# BULLETIN

Bulletin No. 102

Subject: Electrical System - Model PA-12

FIGURE 1a

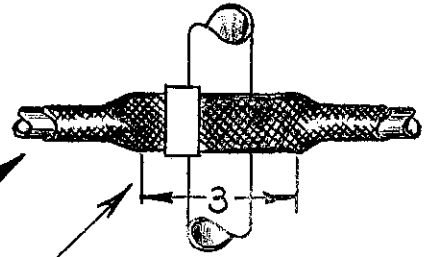
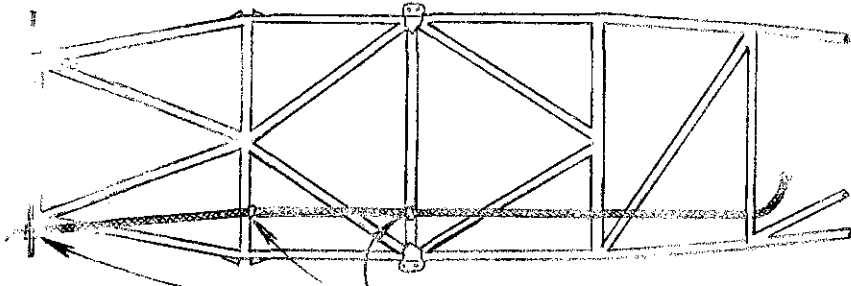
- a. With the compression of the rubber stop blocks in the landing gear, there is a possibility that the starter cable insulation may be damaged where it passes between the landing gear and the fuselage member; This condition is aggravated on some airplanes by the omission of the flattening operation on the starter cable (tube) at this point.

We, therefore, recommend that an immediate inspection be made of the starter cable insulation at this point. Flatten cable, as shown on sketch, if this has not been accomplished; and, where damage or wear is found, wrap with several layers of tape.

CHECK STARTED CABLE FOR INSULATION DAMAGE: FLATTEN AS SHOWN.

REMOVE CABLE FROM CLIP & FLATTEN AS SHOWN. USE WOODEN BLOCKS TO AVOID DAMAGE TO INSULATION.

FIGURE 1b

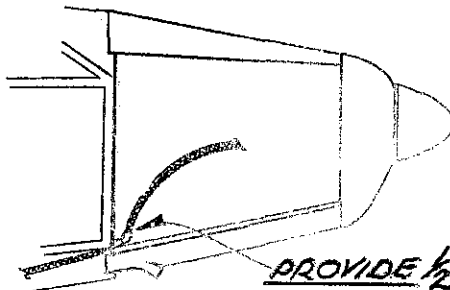
- b. Check all other attachments of the starter cable to fuselage members, and where it passes through firewall; reinforcing these areas with tape, as in point 1a.
- c. An interference has occurred on some installations between the joint in the starter cable and the cowl channel just forward of the firewall. Bend the cable to provide 1/2" clearance with cowl channel.

CHECK THESE POINTS FOR INSULATION DAMAGE

FIGURE 1c

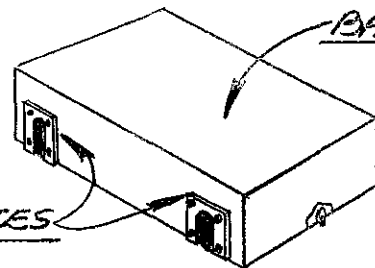
- d. Fiber insulating plates, Part No. 11422-00 (one (1) Req'd.), are also available free of charge, to replace the rubber grommets supporting the starter cable at the firewall and, Part No. 10129-04 on earlier airplanes,

at the battery box, (two (2) req'd). The fiber plates will provide a more serviceable support at these points.

PROVIDE 1/2" CLEARANCE BETWEEN CABLE JOINT & COUPLER CHANNEL.

FIBER PLATE #11422

FIBER PLATES #10129-4

FIGURE 2

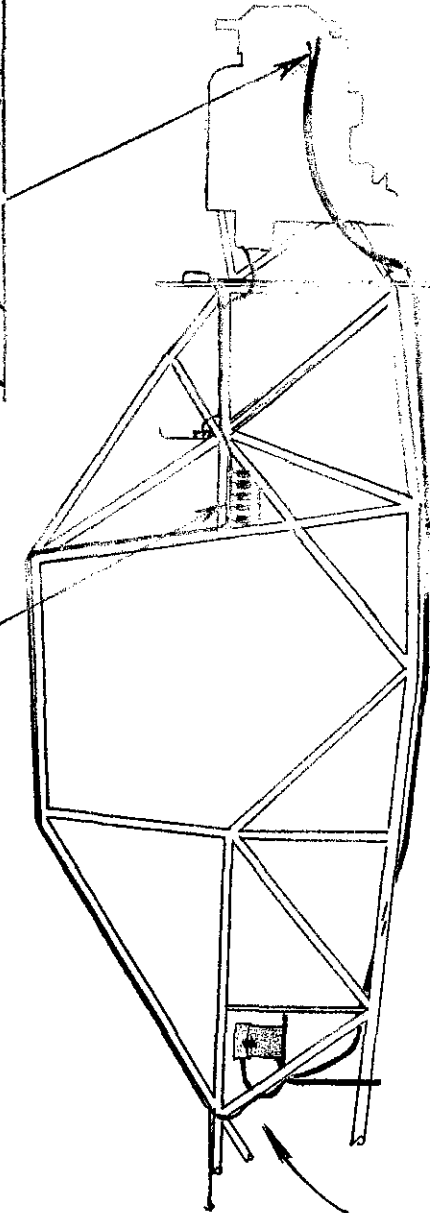
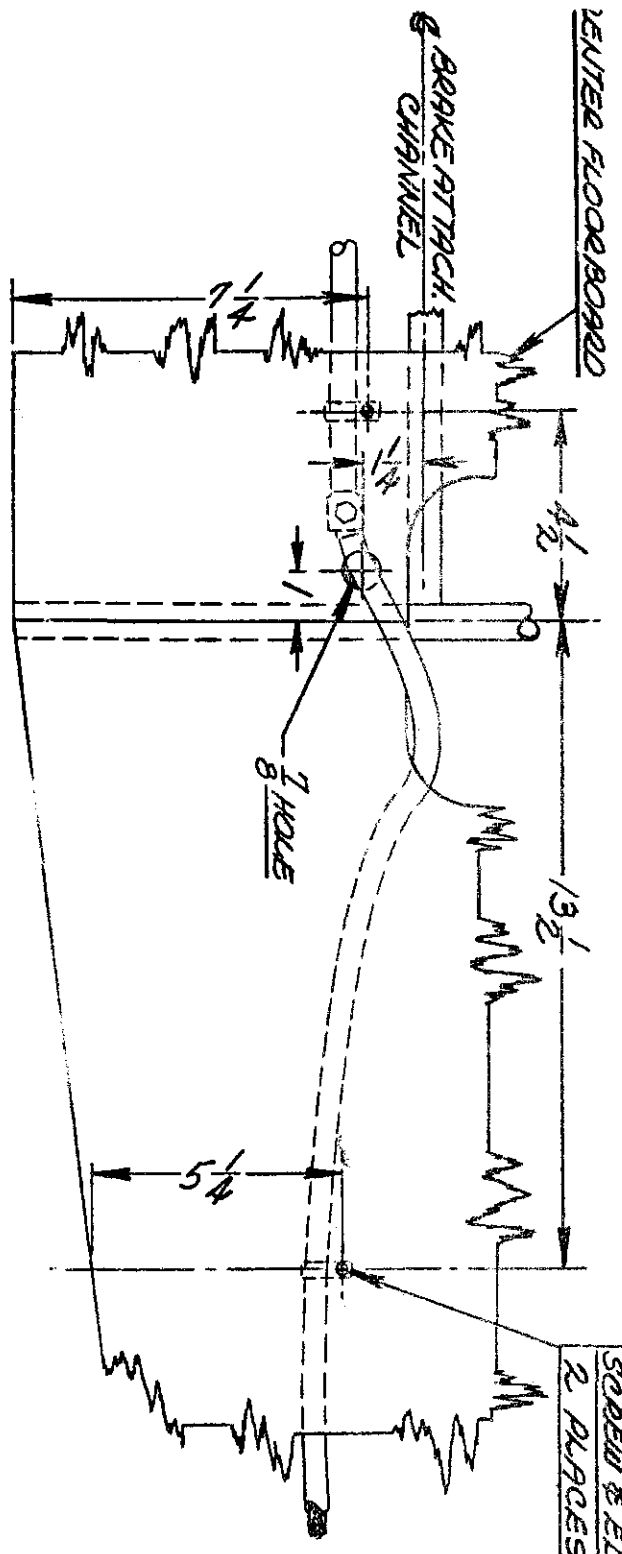
2. An inspection should be made of all other wiring in the fuselage and engine compartment, especially at attachments. Critical points are shown on sketch. Worn or damaged insulation should be generously wrapped with tape.

CHECK SWITCH PANEL FOR  
TERMINAL & WIRE CLEARANCES  
WITH ADJACENT STRUCTURE

CHECK GENERATOR WIRE  
FOR CLEARANCE WITH  
ADJACENT PARTS.

CHECK WIRE INSULATION AT  
FIREWALL GROMMETS &  
ATTACHMENT POINTS.

BATTERY BOX  
DRAIN TUBE - SEE  
PARAGRAPH 4

SOLENOID - SEE PARAGRAPH 3

FIGURE 1  
STARTER CONDUCTOR INST.  
(AFT OF FIDELURALL)

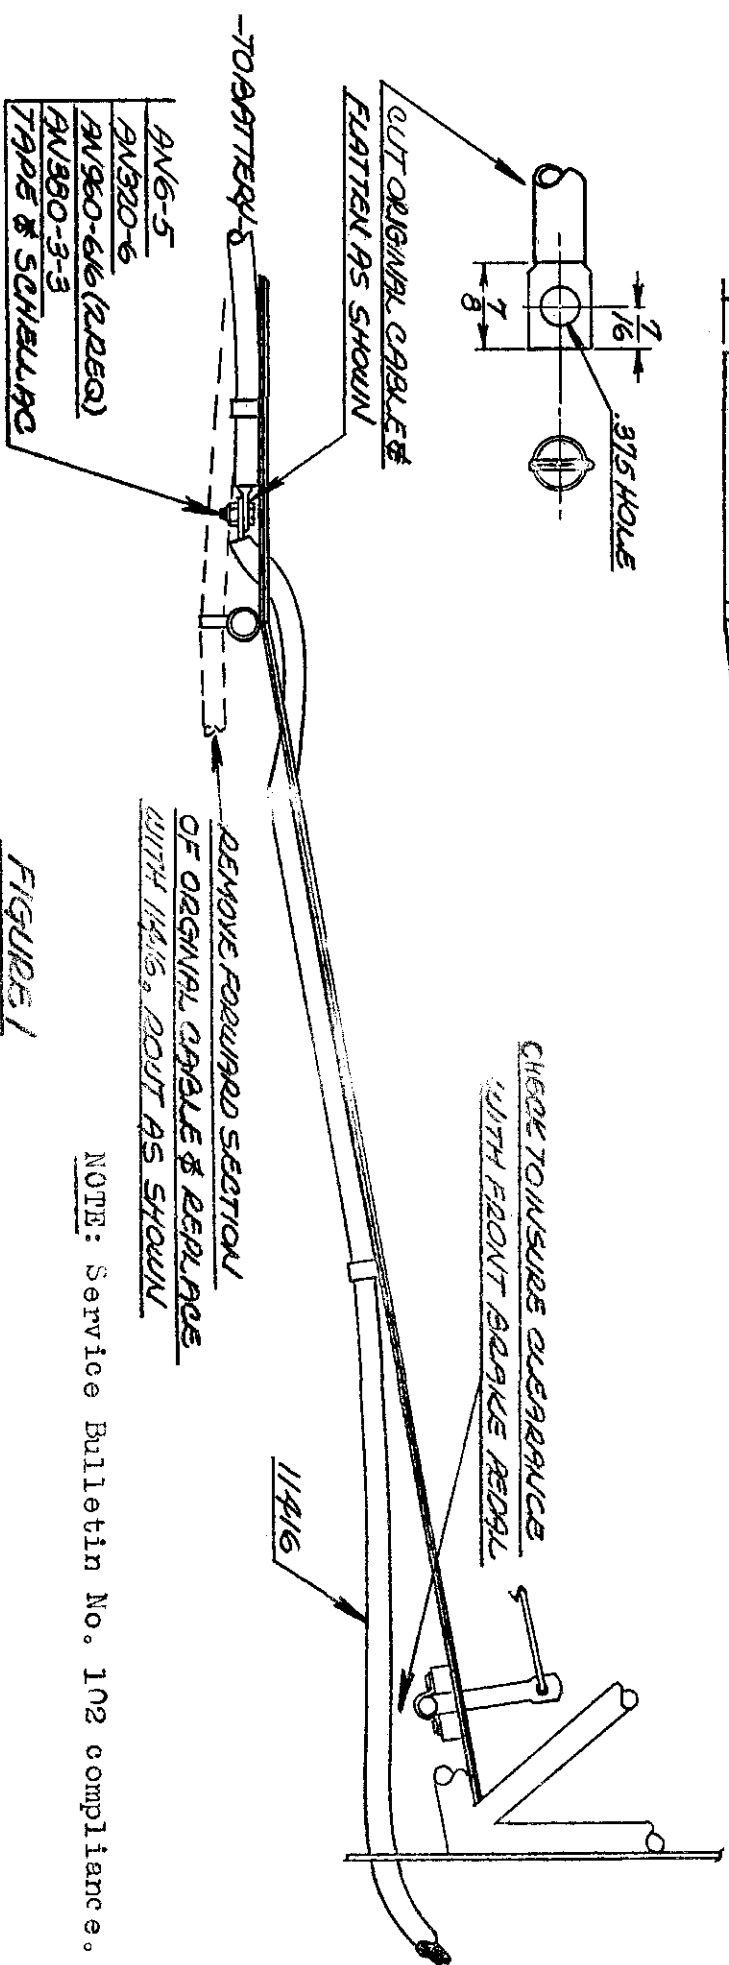
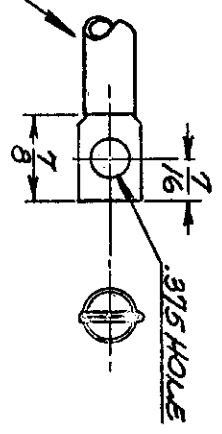
A revised starter cable installation has been developed to eliminate any possibility of pinching the cable at the landing gear and the interference mentioned above. We recommend that this change be made as soon as is practical. Replacement parts, Part No. 11416-00 (One (1) Req'd.) are available free of charge through your distributor.

80032-4 CLAMP ATTACHED WITH #10-32x 5/8 ROUND HEAD 1 3/4 SORBEL & ELASTIC STOP-NUT 2 PLACES
